1073 LIVERPOOL ROAD, MANCHESTER DESIGN AND ACCESS REPORT

TO PLANNING PERMISSION 117897/FO/2017

1073-TGA-XX-XX-RP-A-FI_10_10-00250

This report has been prepared by Tim Groom Architects to describe proposed non-material amendments to the Planning Application Number 117897/FO/2017 and support the Listed Building Consent Application for the revised scheme.

6.0 NORTH ELEVATION

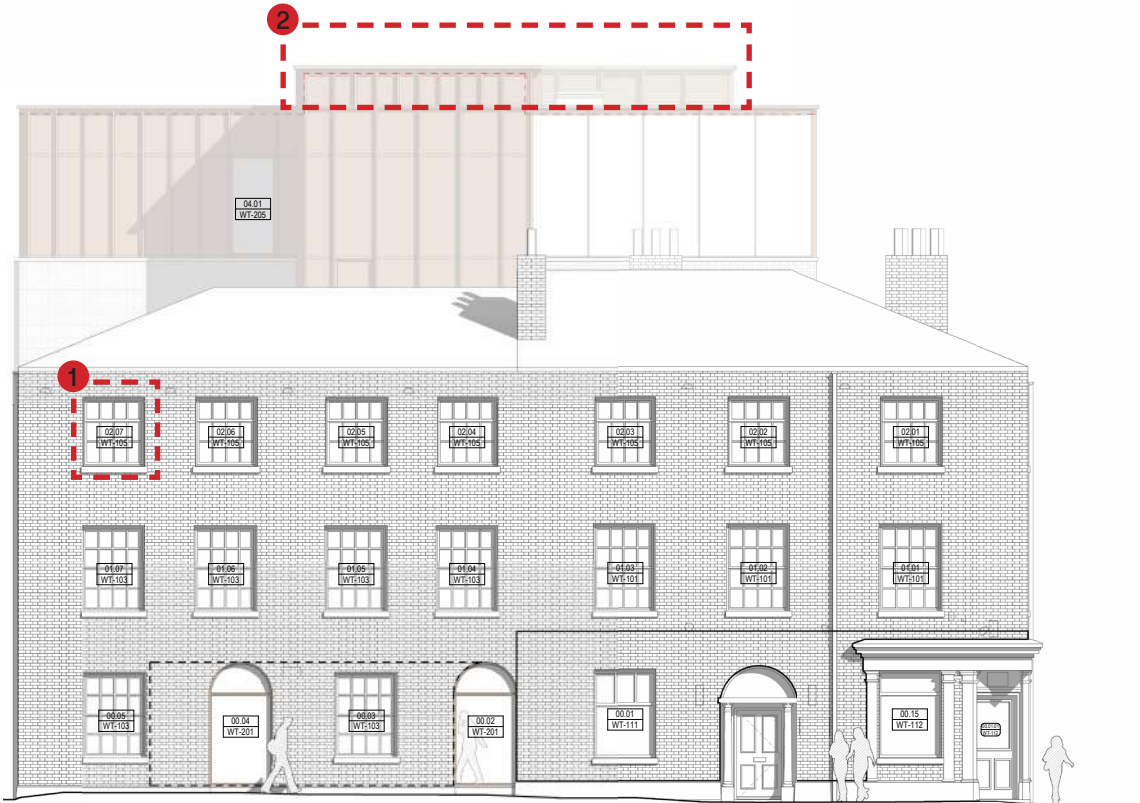
- 1. '4 over 8' and '8 over 8' sashes re-introduced, as seen historically on the building.
- 2. Plant screening extended due to increased plant demand to meet current regulation requirements for the building operation and acoustic requirements.

6.1 SOUTH ELEVATION

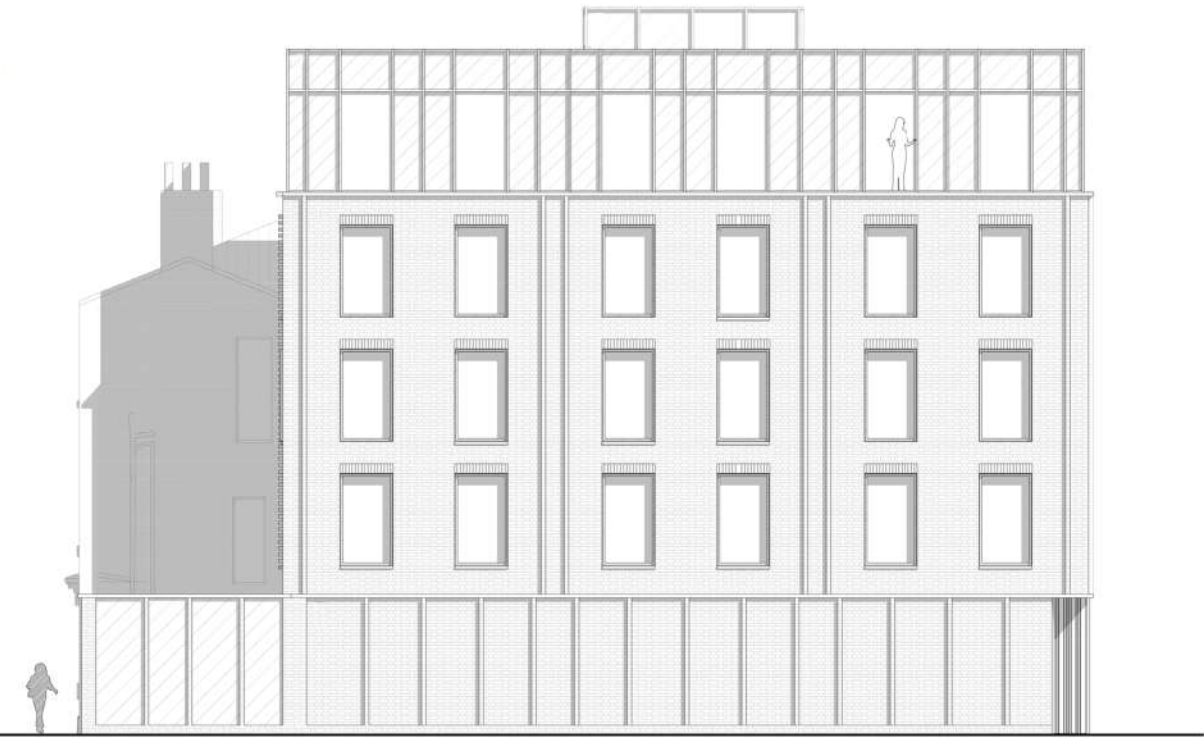
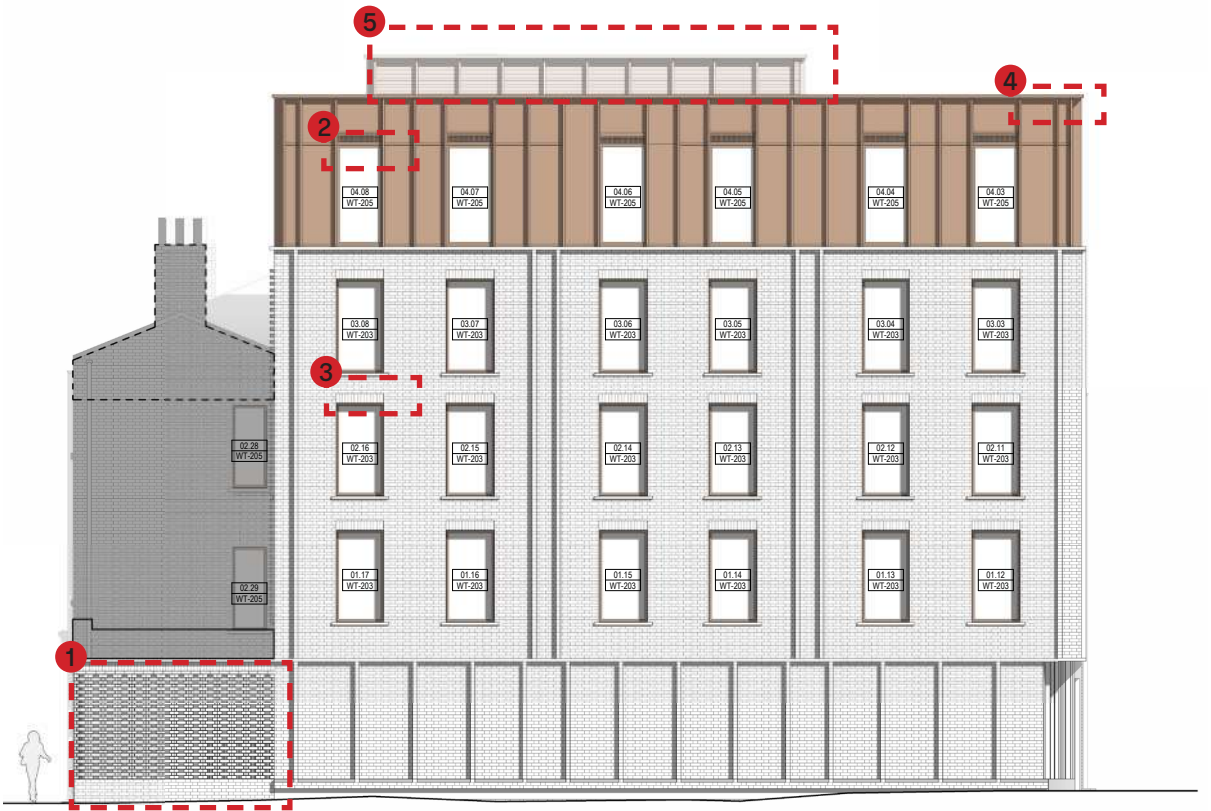
- 1. Bin room elevation metal panels altered to hit-and-miss brickwork to provide required ventilation and continuity to the facade material.
- 2. Decorative panels added to heads of windows for room ventilation.
- 3. Soffit ventilation to brick areas for room ventilation included above windows.
- 4. Parapet height raised due to the addition of a blue roof.
- 5. Plant screening extended due to increased plant demand to meet current regulation requirements for the building operation and acoustic requirements.

6.2 WEST ELEVATION

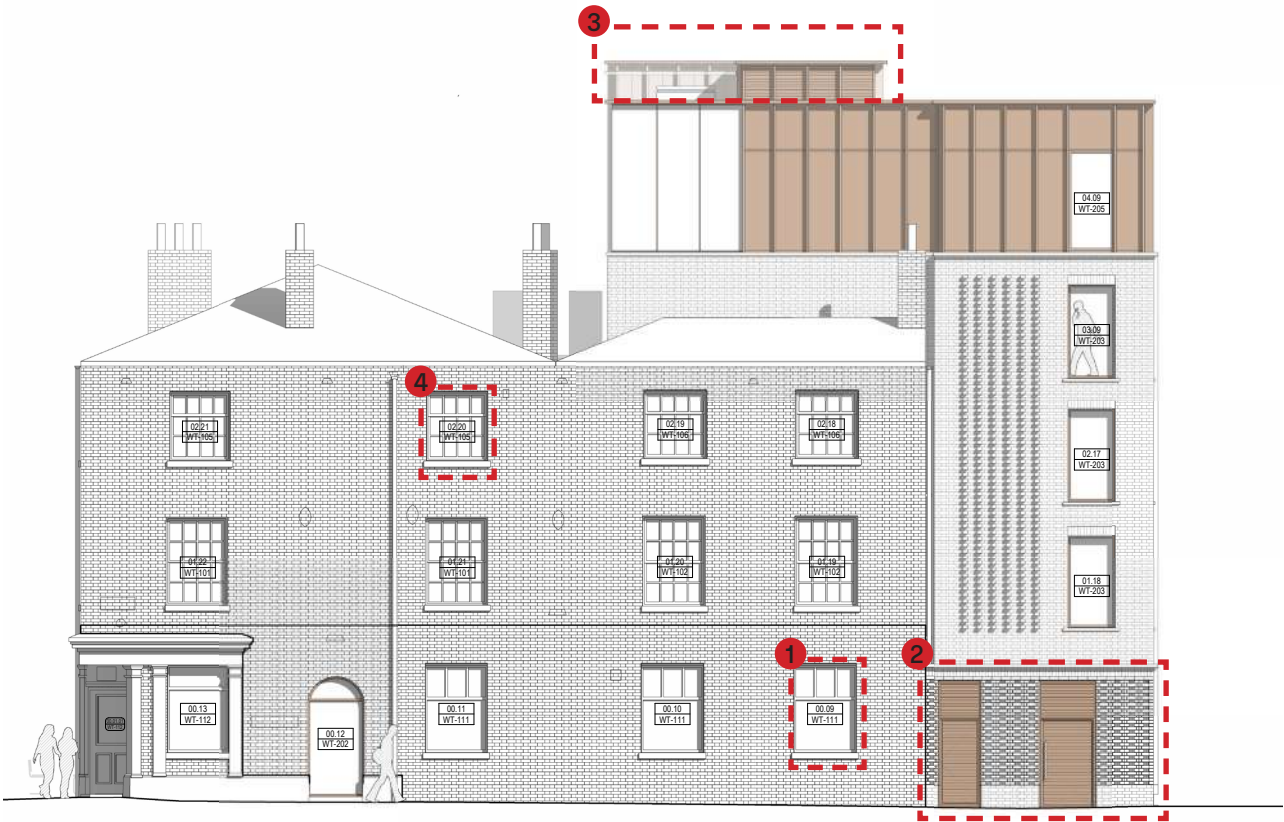
- 1. Window retained, entry door relocated.
- 2. Bin room elevation metal panels altered to hit-and-miss brickwork to provide required ventilation and continuity to the facade material.
- 3. Plant screening extended due to increased plant demand to meet current regulation requirements for the building operation and acoustic requirements.
- 4. '4 over 8' and '8 over 8' sashes re-introduced, as seen historically on the building.

6.3 EAST ELEVATION

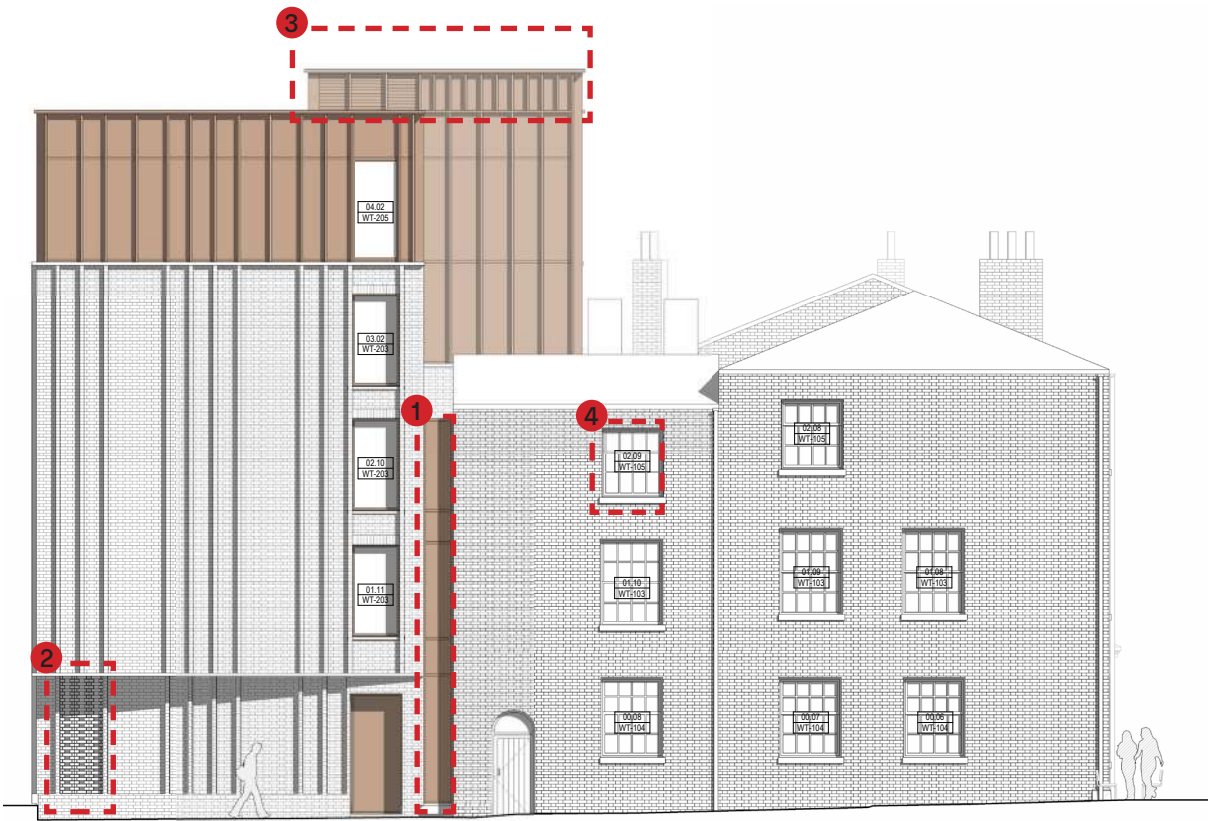
- 1. Amendment to material from glazing to metal panels to provide clear distinction between the two building elements and conceal uninhabited area between the two buildings.
- 2. Addition of hit & miss brickwork discretely below cantilever to the rear of the building for spa plant ventilation.
- 3. Plant screening extended due to increased plant demand to meet current regulation requirements for the building operation and acoustic requirements.
- 4. '4 over 8' and '8 over 8' sashes re-introduced, as seen historically on the building.
